UZBEKISTAN GAS TO LIQUID PROJECT (UZGTL)

HAZOP ACTION CLOSE-OUT REGISTER FOR MAKE-UP H2 COMPRESSOR PACKAGE

UZGTL-HDC-HSE-RP-50-0-0004

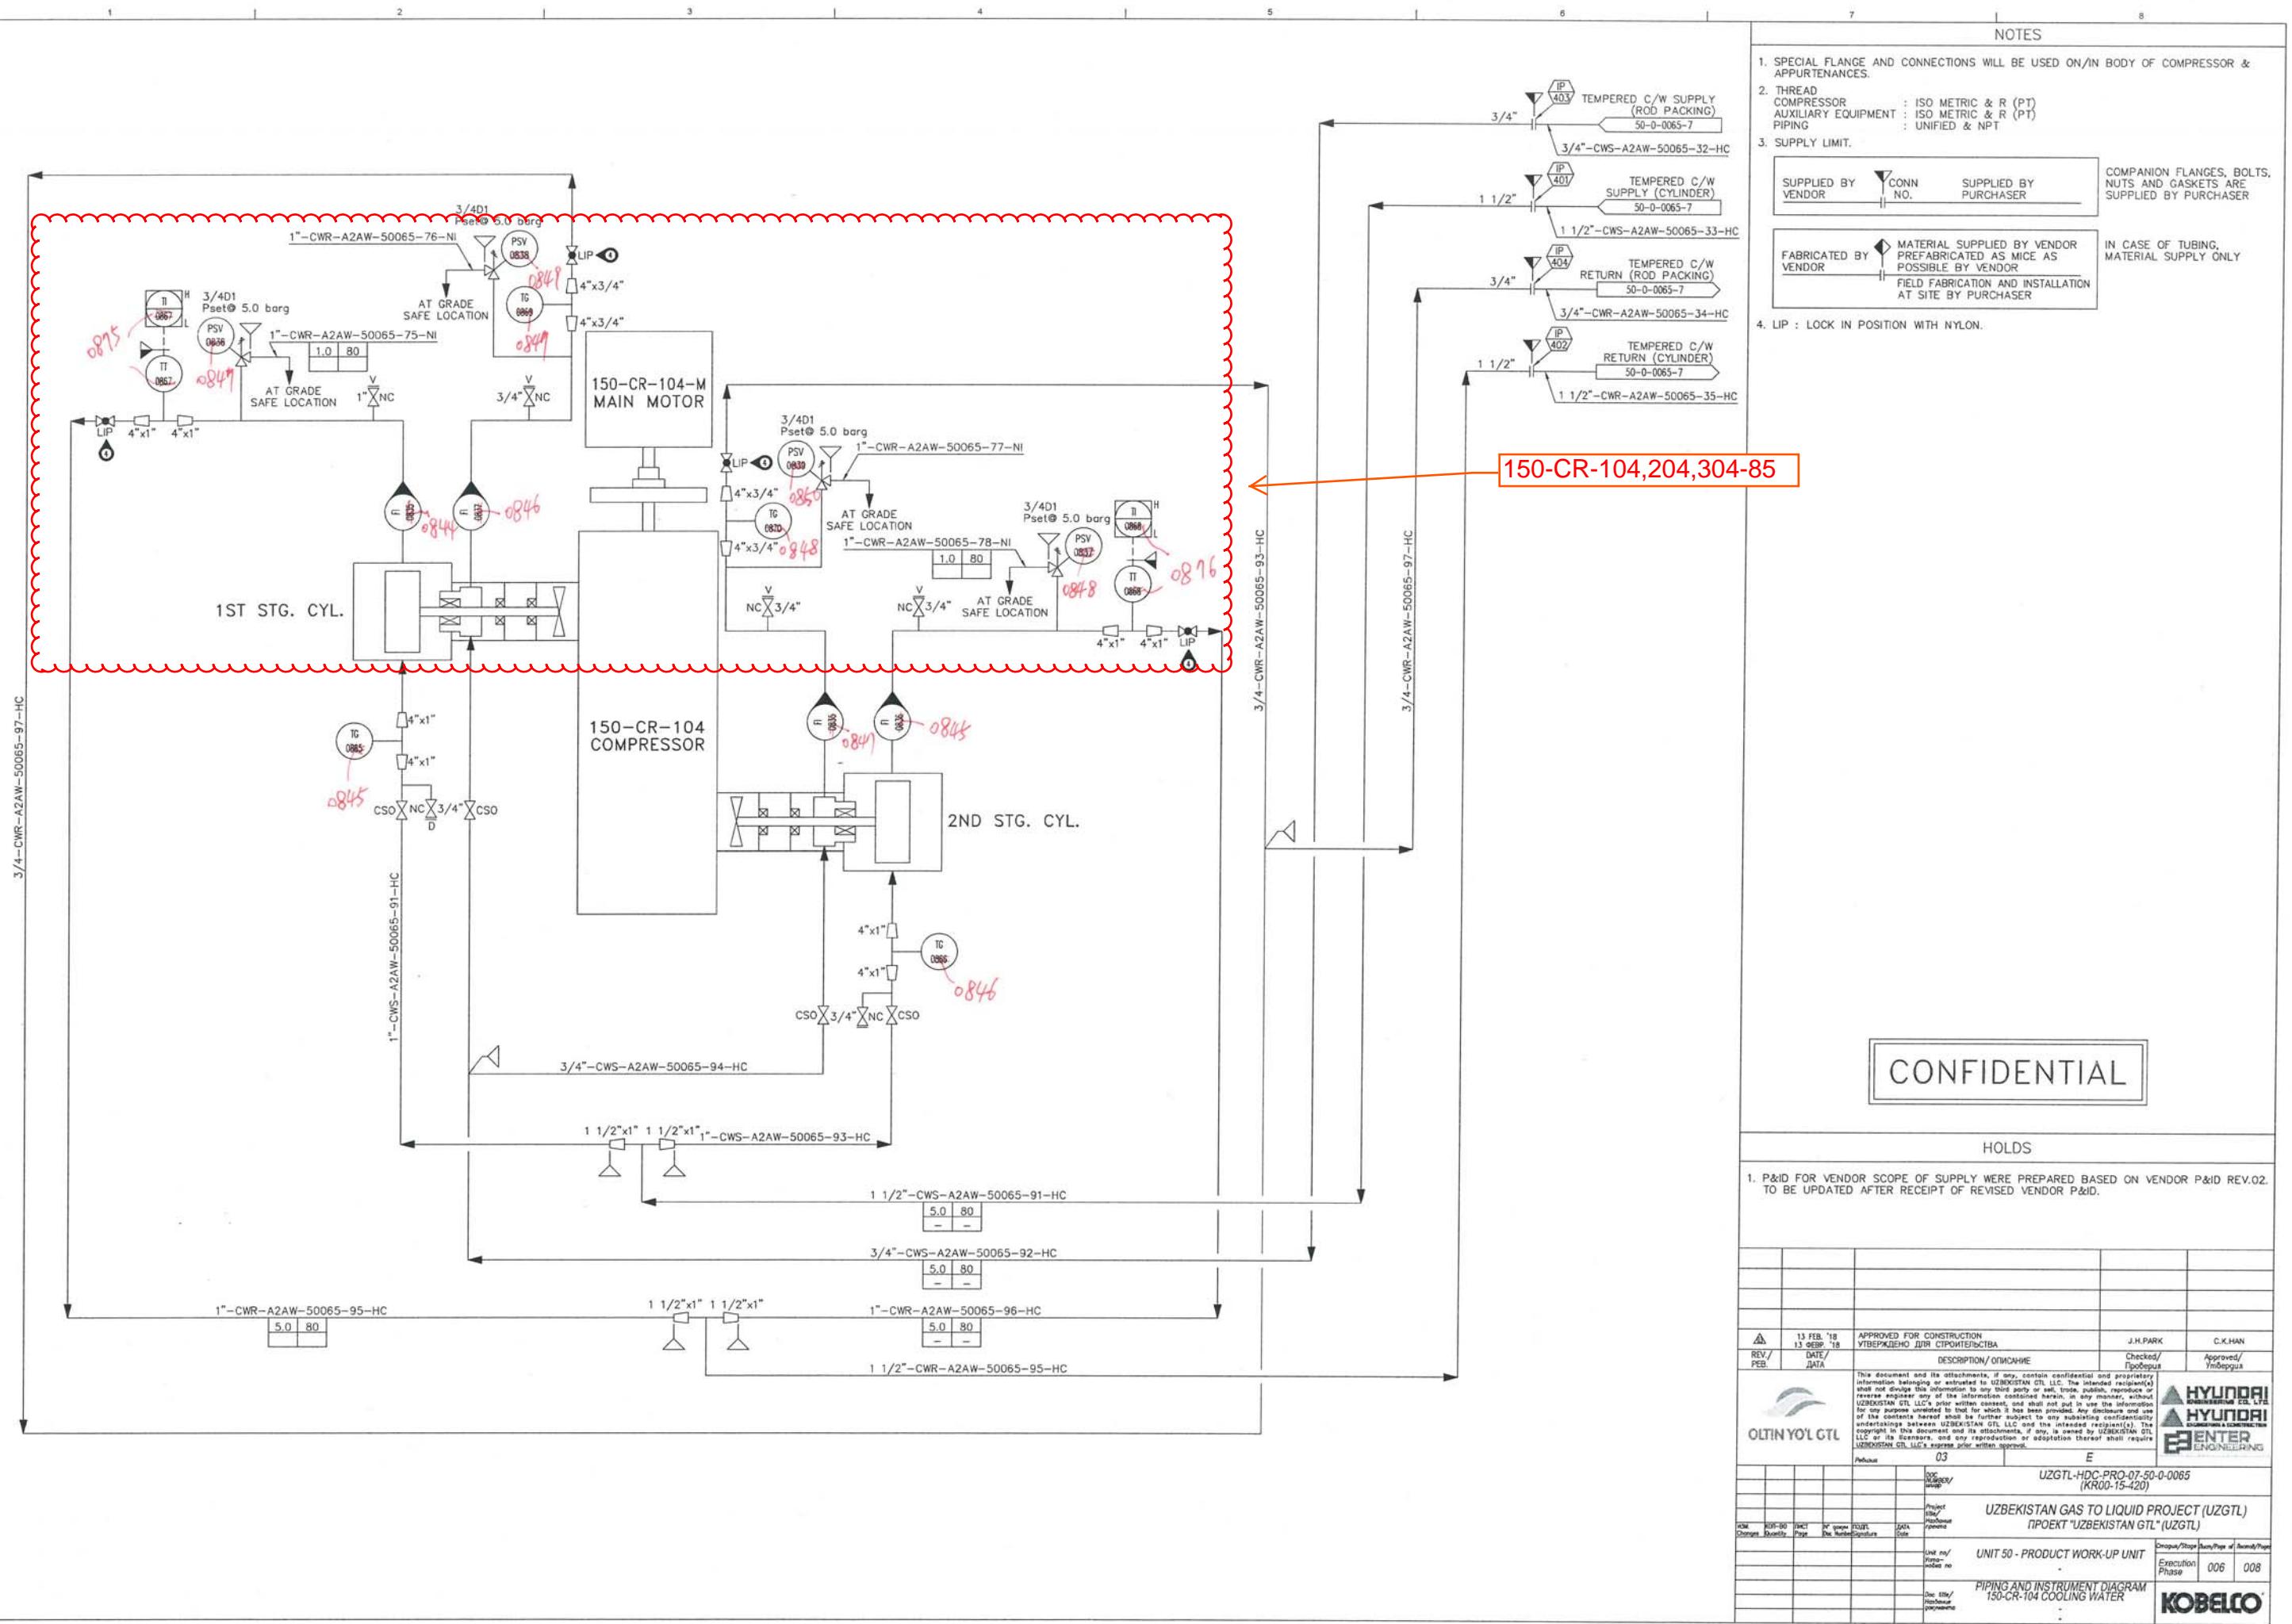
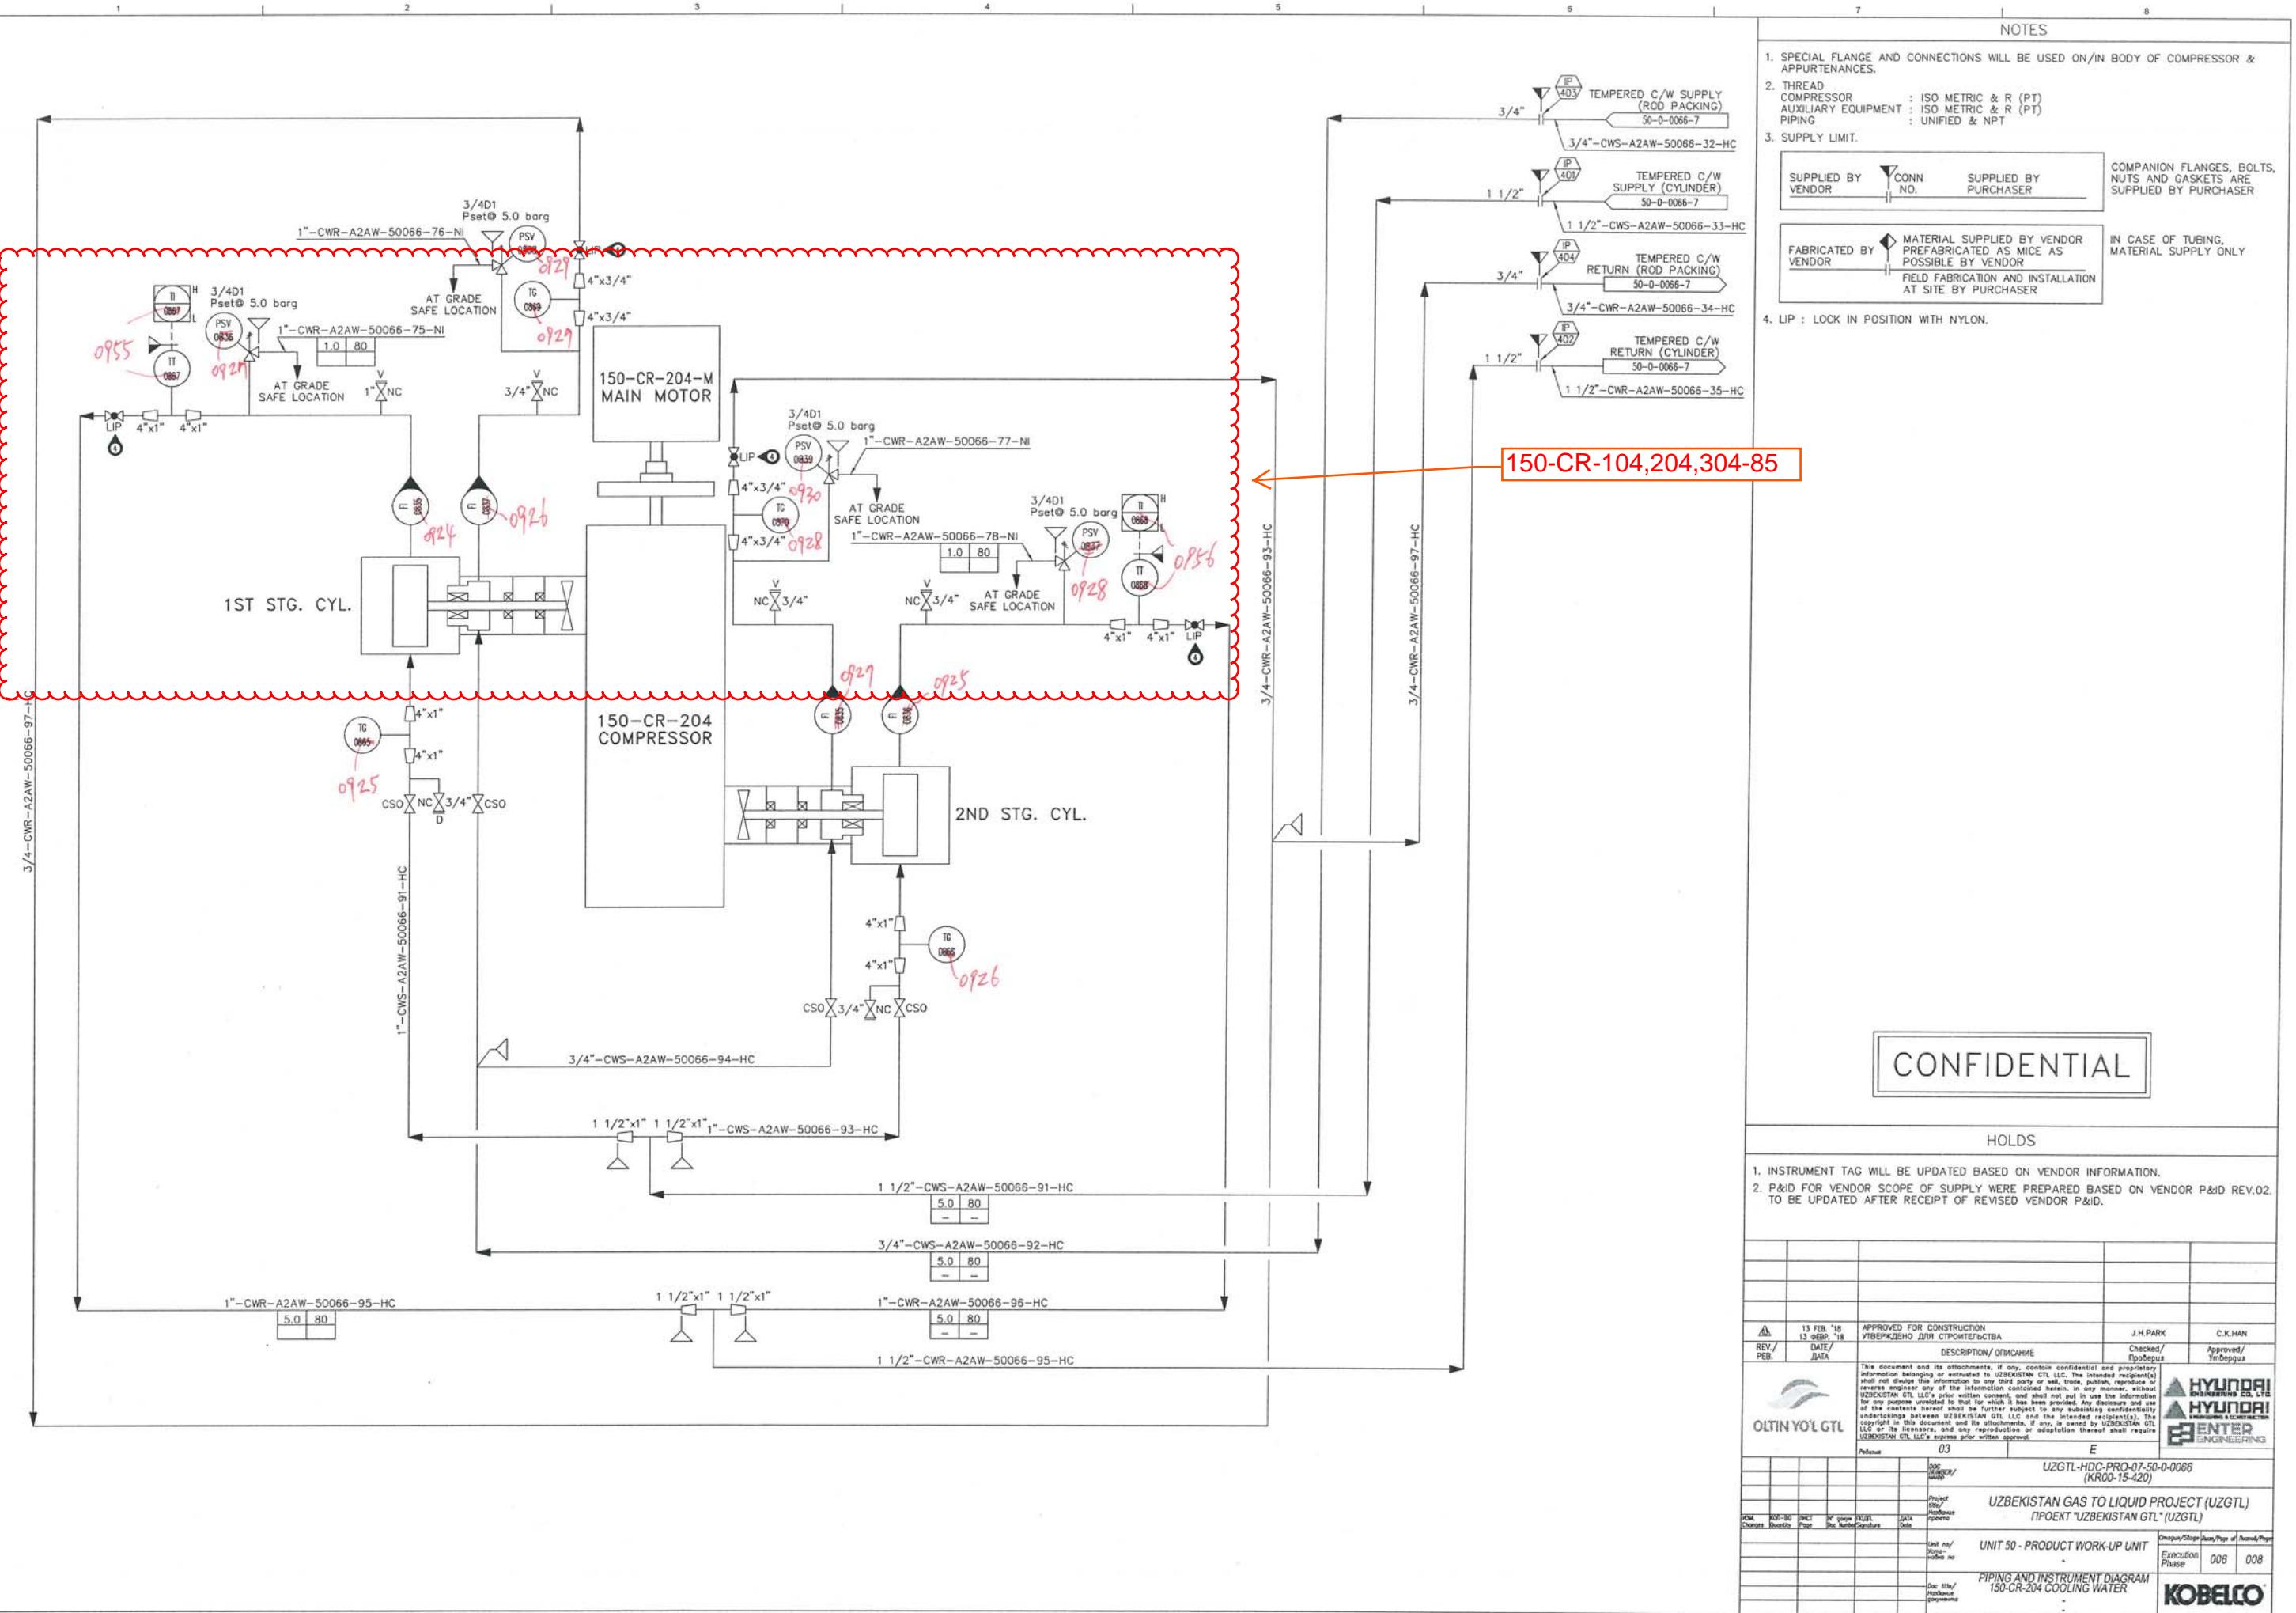
Action No.	150-CR-104/204/304-85				
Action By	PR				
Node No.	3				
Node Description	3. Cooling Water / TCW console				
Cause	3.9.1. Less Temperature of Cooling Water due to 150-TIC-0872A control loop malfunction or failure (150-TV-0832A close)				
Consequence	3.9.1.1. Potential condensate formation of process gas leading to potential piston ring lifetime decrease.				
Safeguards					
Action	Configure 150-TAL-0867A/0868A on DCS				
Response	Incorporated on P&ID (50-0-0065/66/67-6). 150-TAL-0867A/0868A on DCS is provided on AFC P&ID. (Please refer to attached P&ID, UZGTL-HDC-PRO-07-50-0-0065/66/67-6)				
CONTRACTOR			OWNER		
Position	Signature	Date	Position	Signature	Date
Process Engineer	<u>B.M.Hwang</u> 	10-Apr-2018		_____
